ES_LPC435x/3x/2x/1x

Errata sheet LPC435x/3x/2x/1x

Rev. 2 — 20 October 2012

Fig 1. PMC wakeup keep-out area

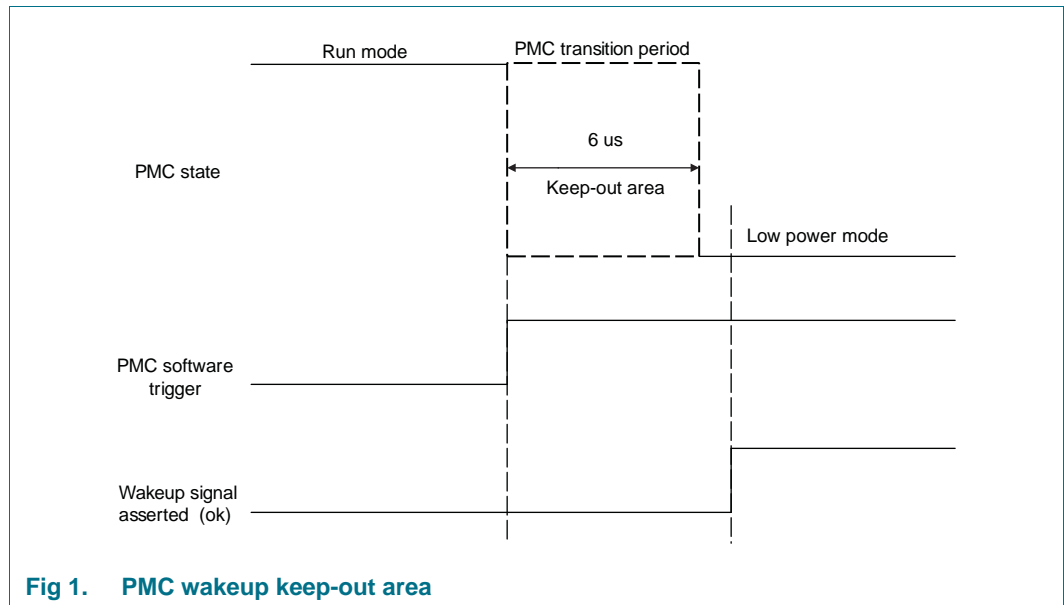
When the chip is in a transition from active to Deep Sleep, Power Down, or Deep Power Down, wakeup events are not captured and they will block further wakeup events from propagating. The time window for this transition is 6 uS and is not affected by the chip clock speed. After a wakeup event is received during the PMC transition, the chip can only recover by using an external hardware reset or by cycling power.

Make sure that a wakeup signal is not received during the Deep Sleep, Power Down, or Deep Power Down transition period. An example circuit to work around this could include an external 6 uS one shot which could be triggered via software using a GPIO line when entering Deep Sleep, Power Down, or Deep Power Down mode. The one-shot's output could be used to gate the wakeup signal(s) to prevent receiving a wakeup signal during the PMC transition period. Depending on the system design, it may also be needed to latch the wakeup signal(s) so that they will still be present after the one-shot's 6 uS timeout.
